ZONING BOARD OF APPEALS

Review of Plans: Ferrante Site Plan, 1031 Route 9W, Upper Grandview, NY  
Section 71.09 Block 1 Lot 17 R-22 zone

Subject: **Ferrante Site Plan**  
1031 Route 9W, Upper Grandview  
71.09/1/17; R-22 zoning district

As-Built Pool Site Plan package as prepared by Jay A. Greenwell, last revised 10/19/2022.

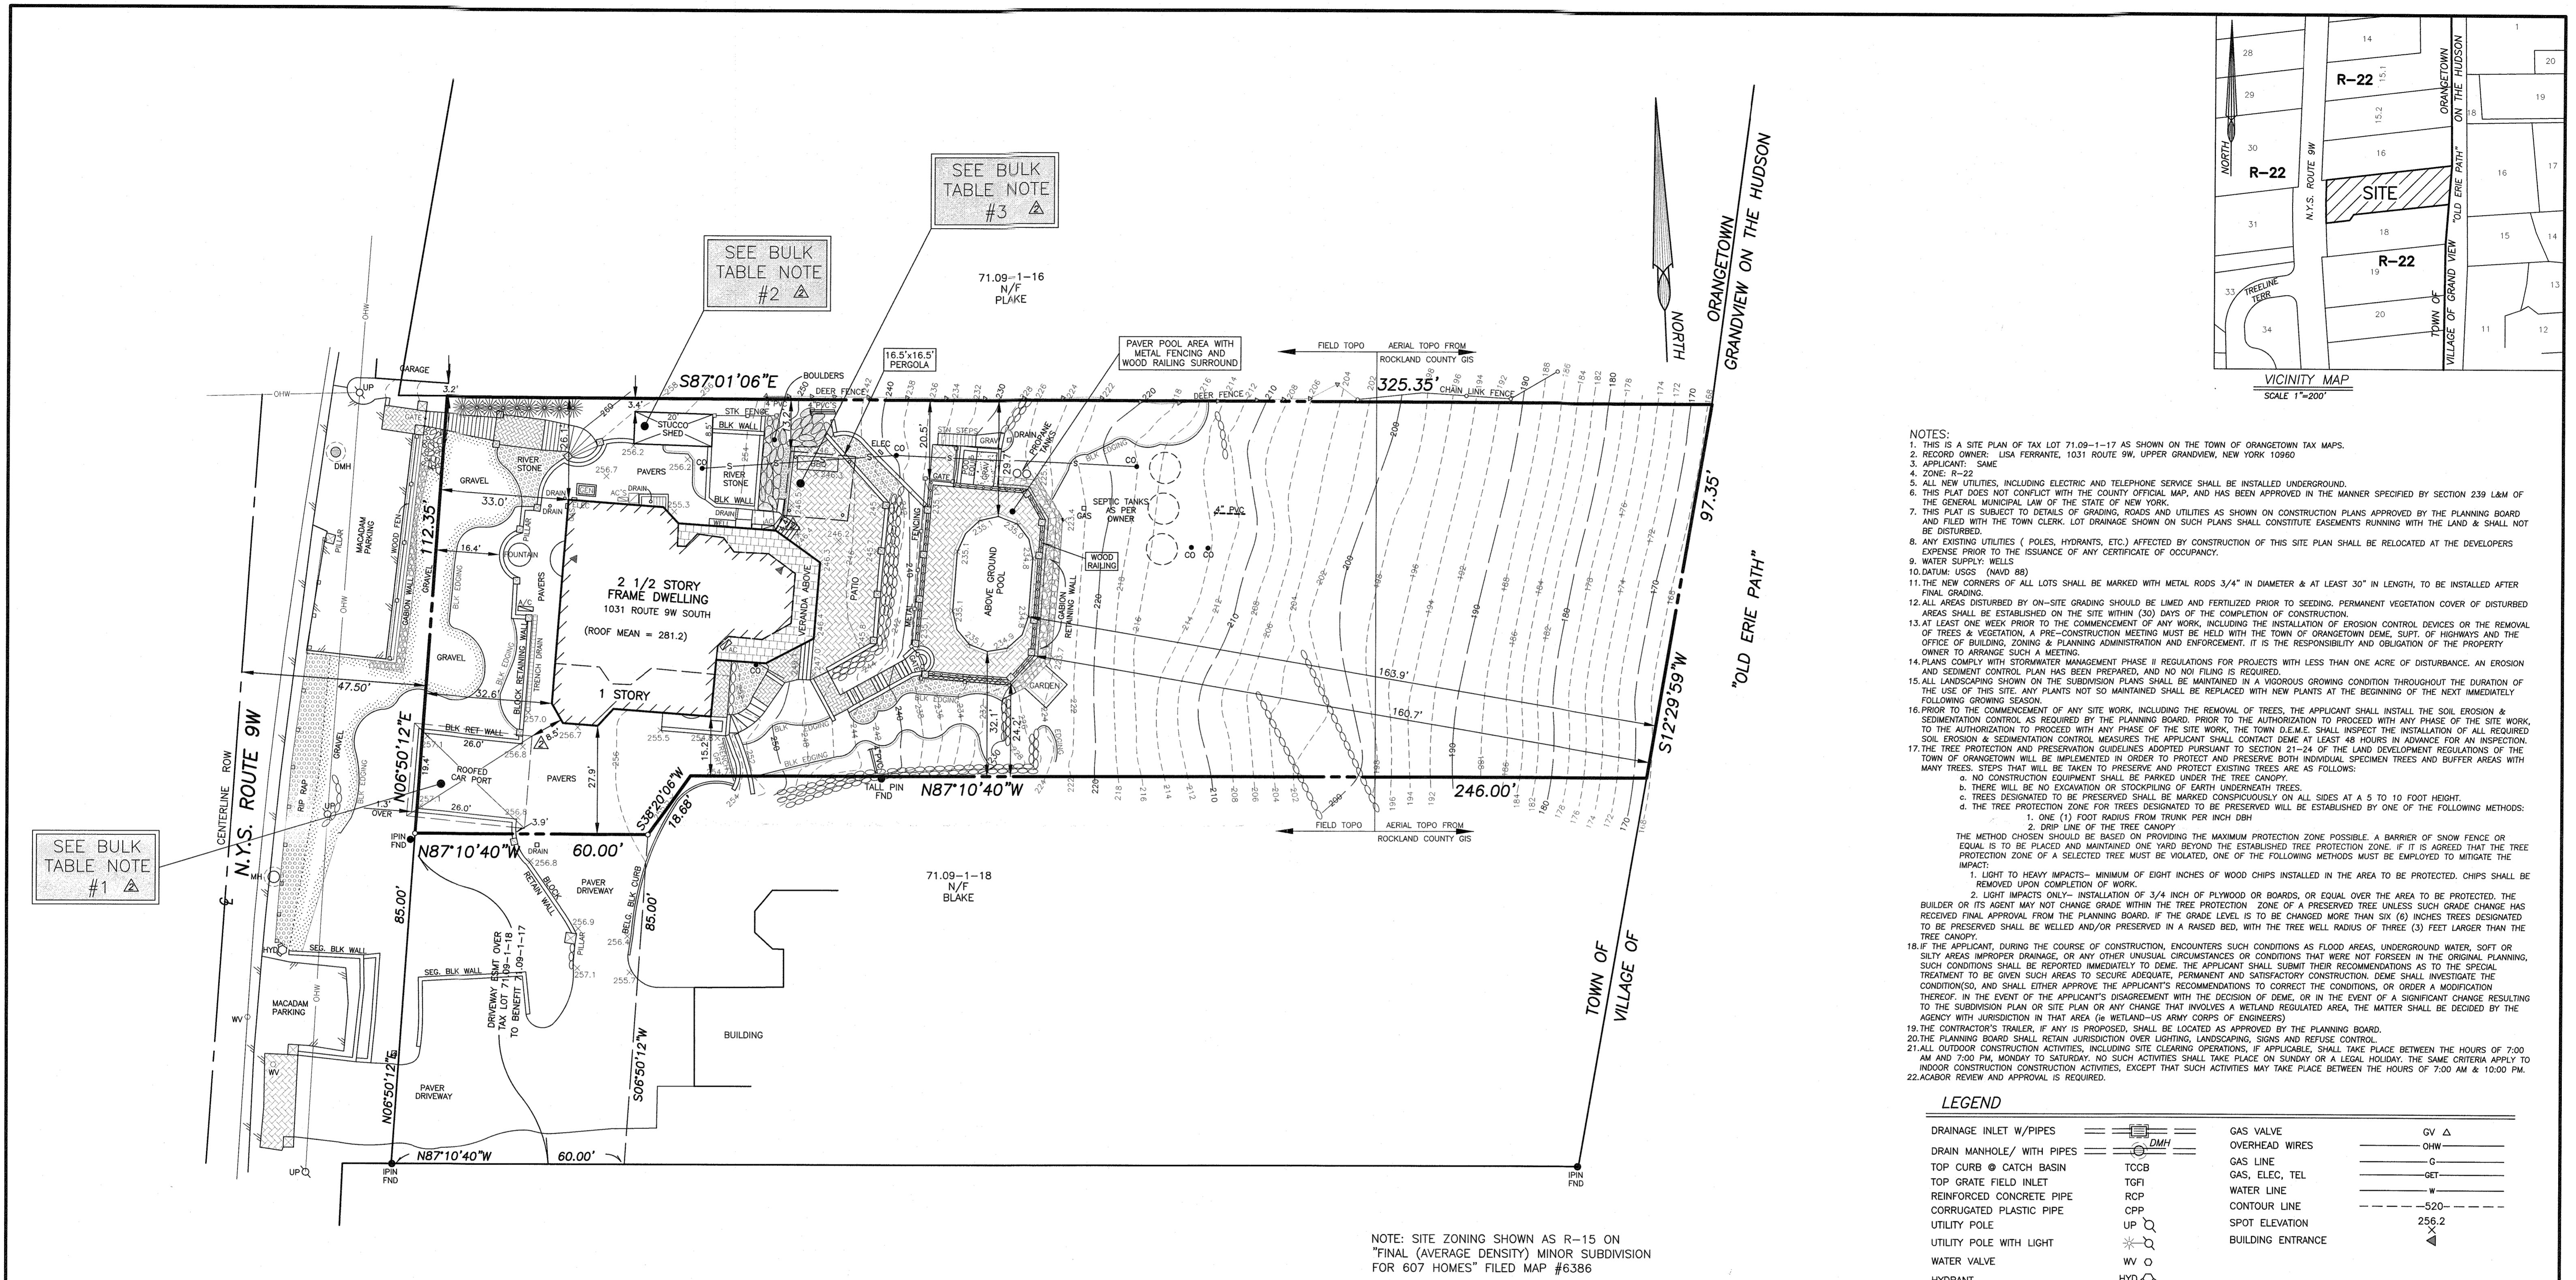
- 1) The Roofed Car Port is shown as being located 1.3' over the property line on 9W. The structure must be removed or obtain approval from NYS.
- 2) The following variances are required:

- a) Per Chapter 43, Article V, section 5.227, "A building or structure... accessory to a single-family... may be located in any required rear yard or side yard..." Variance required for accessory structure located in front yard.

- b) The car port is located 8.5' from the main dwelling, per Chapter 43, Article V, section 5.153; Location of accessory buildings ...no accessory building ... shall be closer to any principal building ... than a distance equal to the height of such accessory building... and in no event less than 15 feet.

- c) The Stucco Shed is located 3.4' from the north property line with 5' required.
  - d) The Pergola is located approximately 4.4' from the main dwelling, per Chapter 43, Article V, section 5.153; Location of accessory buildings ...no accessory building ... shall be closer to any principal building ... than a distance equal to the height of such accessory building... and in no event less than 15 feet.

- e) The bulk table indicates that the FAR of .23 is an existing condition, however this is not factual as the roofed over carport, shed and pergola were constructed without obtaining the required permits and CO's. Per chapter 43, table 3.12, R-22 District, Column 4, max FAR permitted is .20 with .23 proposed.

- CAR PORT IS OVER THE FRONT LOT LINE. STRUCTURE MUST BE REMOVED OR MODIFIED, OR APPROVAL OBTAINED FROM NYS DOT. ADDITIONALLY, A VARIANCE IS REQUIRED FOR ACCESSORY STRUCTURE IN FRONT YARD (ACT. IV, SECTION 5.227). ALSO, VARIANCE REQUIRED FOR PROXIMITY OF CARPORT TO DWELLING (REQ:15'; ACTUAL:9.5'); ART. V, SECTION 5.153.
- SHED AT NORTH PROPERTY LINE REQUIRES A SIDE YARD VARIANCE.
- VARIANCE REQUIRED FOR PROXIMITY OF PERGOLA TO DWELLING (REQ.=15'; ACTUAL=4.4'); ARTICLE V, SECTION 5.153.
